**American Samoa Power Authority**

ISSUANCE DATE: August 17, 2020  
RFQ NO.: RFP No. ASPA20.042 East Side Village Package V Phase II REBID  
SUBJECT: Addendum No. 1

The American Samoa Power Authority hereby issues Addendum No. 1 to amend Request for Proposals (RFP) requirements. This addendum is issued pursuant to the conditions of the RFP documents and is hereby made part of the RFP. The addendum serves to clarify, revise, and supersede information contained in the RFP. The Offeror must acknowledge receipt of this addendum in the appropriate space provided in the Addendum Form. Failure to do so may subject the Offeror to disqualification.

DRAWING TITLE:  
**LIFT STATION # 4\_NEW FENCE\_LAYOUT**

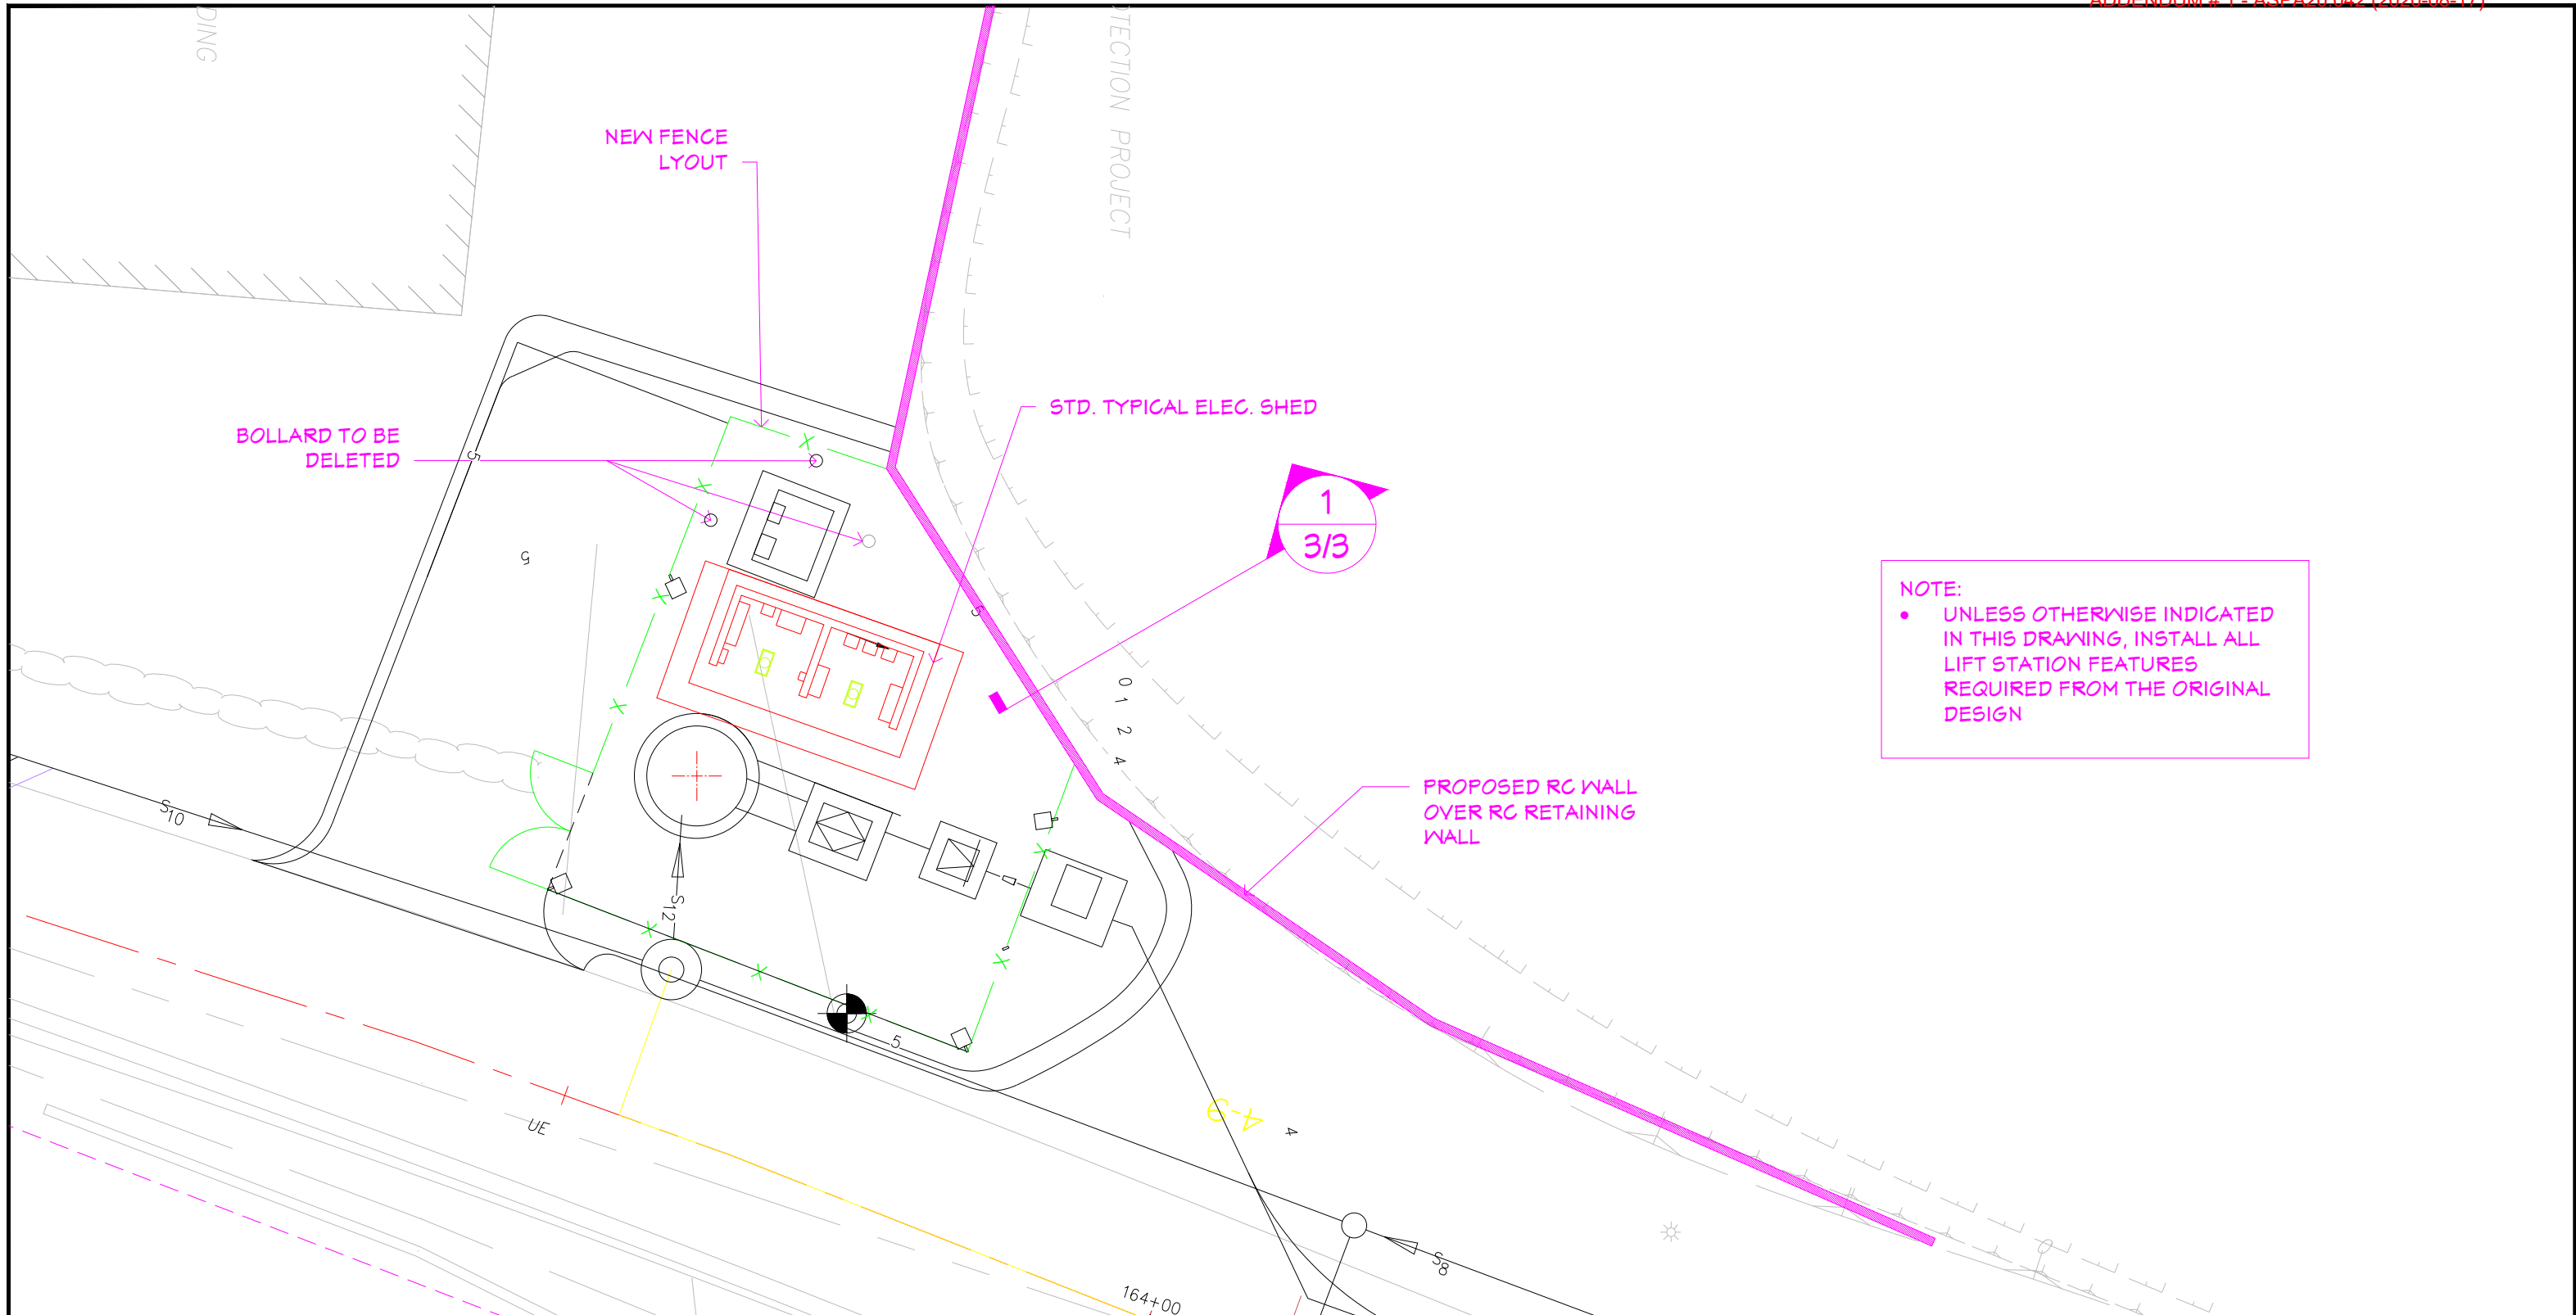
Response: <i>Either option is acceptable, it is up to the contractor which one to use.</i>
Q25. On LS #4 and #5, is there a construction of tri bars involved aside from the concrete retaining wall?

Response: Yes, revetment is required. Use DPW standard design for armour rock or tri-bar, whichever is more economical
Q26. Dwg C-043 shows SFM4 line disconnected from the rest of the line. Is this an AutoCAD error? Dwg C-044 shows SFM4 line disconnected from the rest of the line. Is this an AutoCAD error? Dwg C-038 shows SFM6 line disconnected from the rest of the line. Dwg C-037 shows SFM6 line disconnected from the rest of the line. Are these AutoCAD errors? SFM lines typically are disconnected on the main line runs. Is this an AutoCAD error?

DRAWING TITLE:  
**RETAININGE WALL DETAILS**

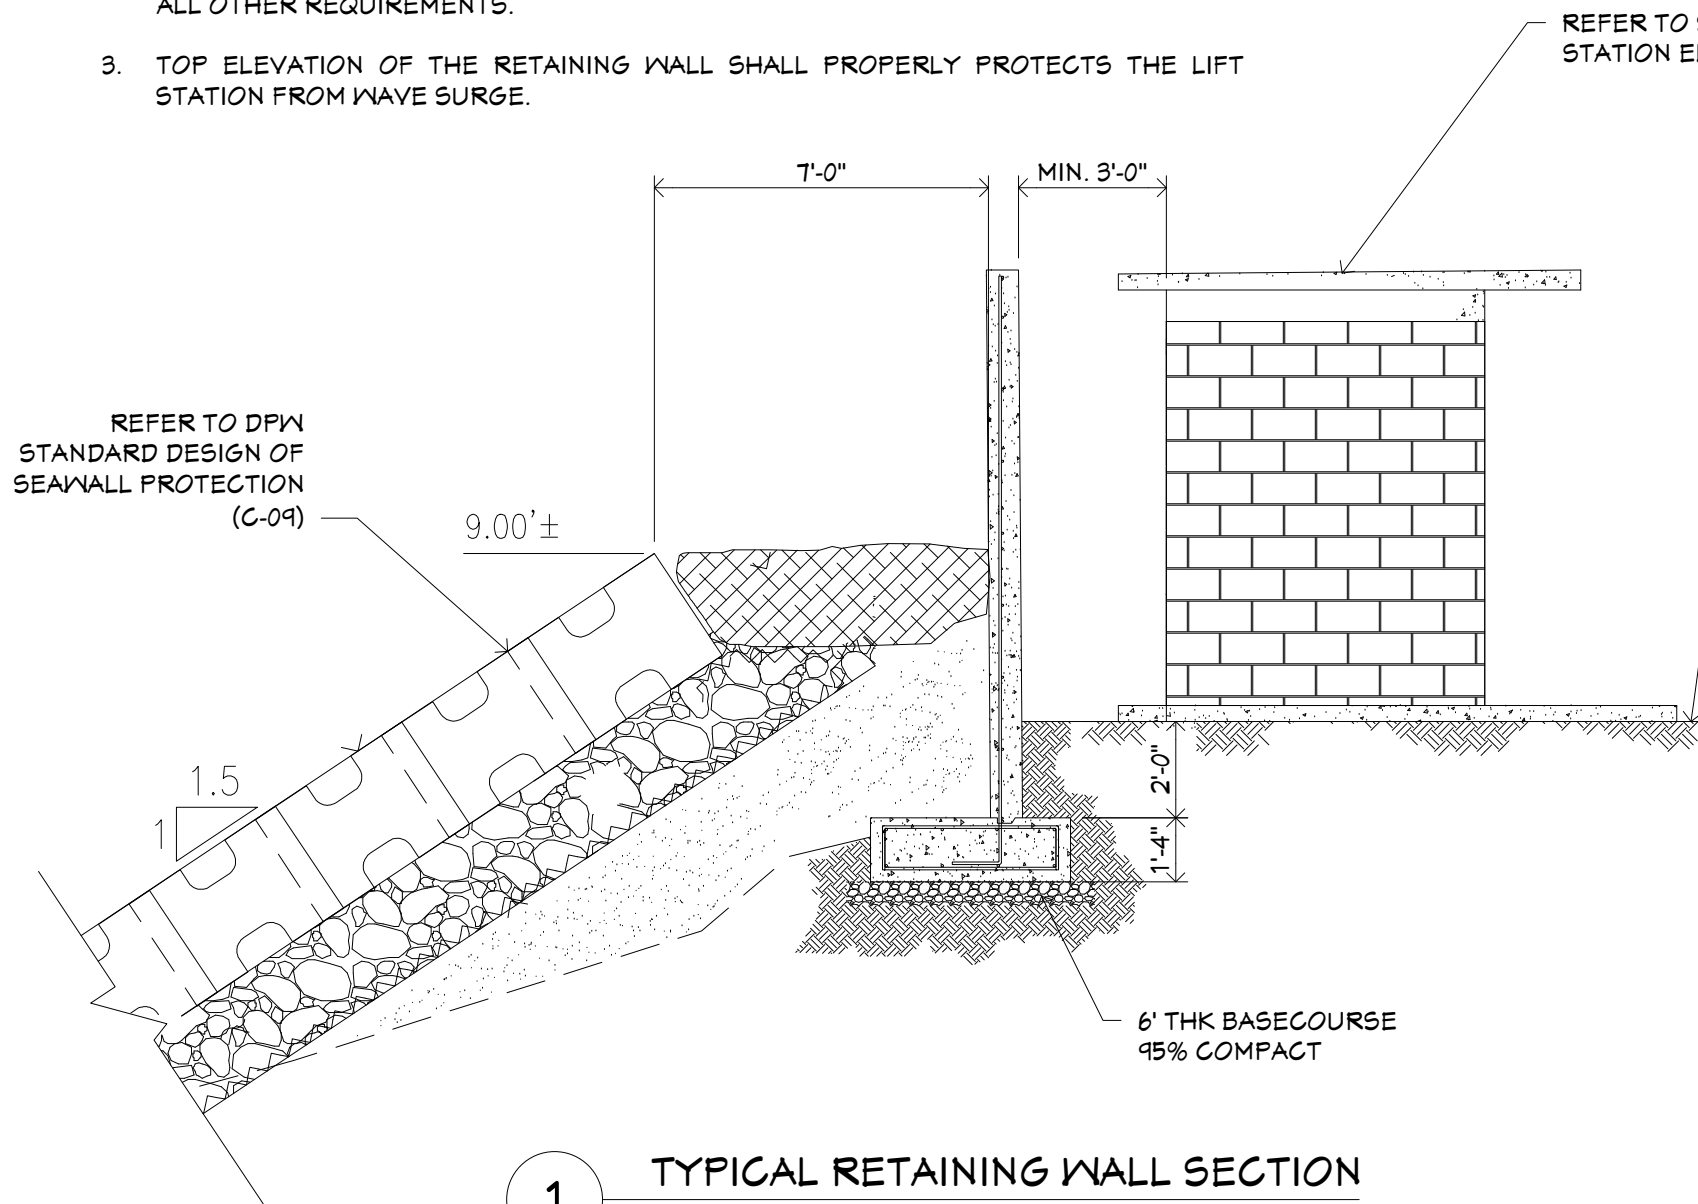
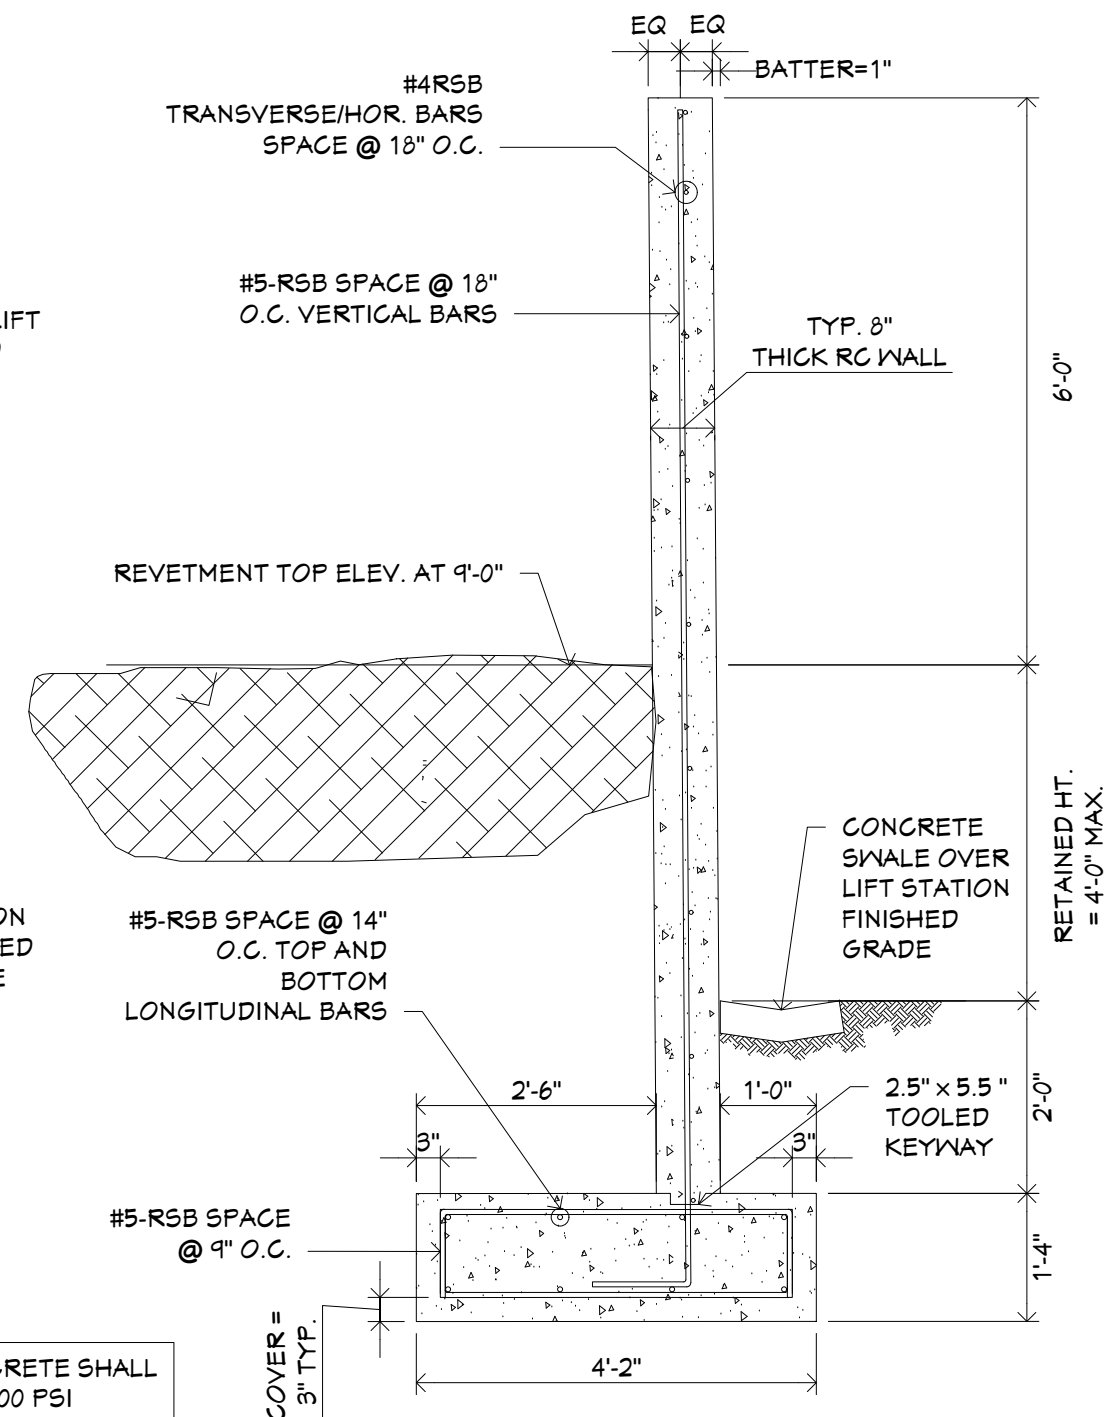
Response: <i>Provided drawings are intended to show the design and specifications of the sea wall protection only.</i>
Q3. Please provide details of retaining wall in shoreline embankment as referenced on drawing C9.

Response: <i>Refer to attached details at the end of this document</i>
Q4. Please confirm defects liability period and advance payment %.
Response: <i>The defects liability period shall be one year from the completion date. ASPA will not consider any bids that require 100% advance payment.</i>
Q5. Would the client be willing to consider an alternate period, or is there a client constraint on the completion date?

1. INSTALLATION OF NEW TRIBAR REVETMENT, EMBANKMENT, RETAINING WALL, INSTALLATION OF CATCH BASINS AND DRAIN PIPE OUTLETS AND OTHER AS REQUIRED SHALL CONFORM WITH DPW STANDARD DESIGN.
2. THE CONTRACTOR SHALL COORDINATE WITH DPW FOR ALL NECESSARY DESIGN DETAILS OR SPECIFICATIONS, ALLOWABLE SITE SPECIFIC LOCATION/BOUNDARY, SURVEY AND PROPOSED LOCATION OF TIE-IN POINT (FOR FUTURE EXPANSION) AND ALL OTHER REQUIREMENTS.
3. TOP ELEVATION OF THE RETAINING WALL SHALL PROPERLY PROTECTS THE LIFT STATION FROM WAVE SURGE.
